<b>TITLE</b>			LOGIC TO CHASSIS GROUND FEED THROUGH		PIB NO. DK-3003
PRODUCT LINE:	TAPE DISK FORMATTER	EQUIPMENT CHANGED LOGIC PCBA	MODEL SERIES AFFECTED	EFFECTIVE DATE	
	 X 	102831-XX	D3000	6-24-74

**TITLE** LOGIC TO CHASSIS GROUND FEED THROUGH

PIB NO.  
DK-3003

FIG. 1

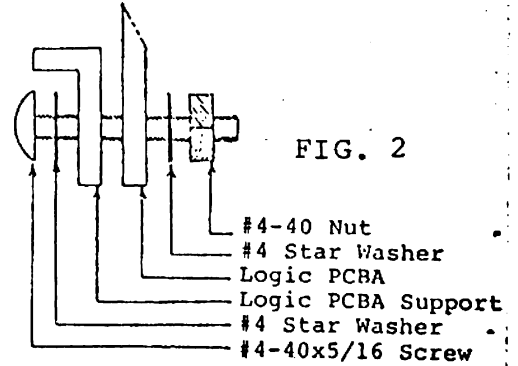
**PURPOSE:** Rivets are now being used to attach the Logic PCBA support angle to the Logic PCBA. Possibilities exist that a small quantity of Model D3000 Disk Drives manufactured from April 1, 1974 through June 1, 1974, could have a riveted connection between logic and chassis ground. The support angle (P/N 102697-01) provides logic ground to chassis ground (base casting) feed through via the hinged standoffs (P/N 102729-01). Logic ground is normally transferred to the support angle by a screw located directly beneath Circuit No. U109. (Ref. Fig. 1, P.2). A small, but unknown number of these screws could have been replaced with rivets. Normally this poses no problems, however, a screw with locking star washers provides a more desirable grounding technique.

**REWORK INSTRUCTIONS:** Referencing Fig. 1, P.2, locate circuit U-109 in Area C-6. Beneath U109, remove rivet with the small diagonal cutters. Replace rivet with the #4 screw, washers and nut using the tolerance stackup depicted in Fig. 2, P.2.
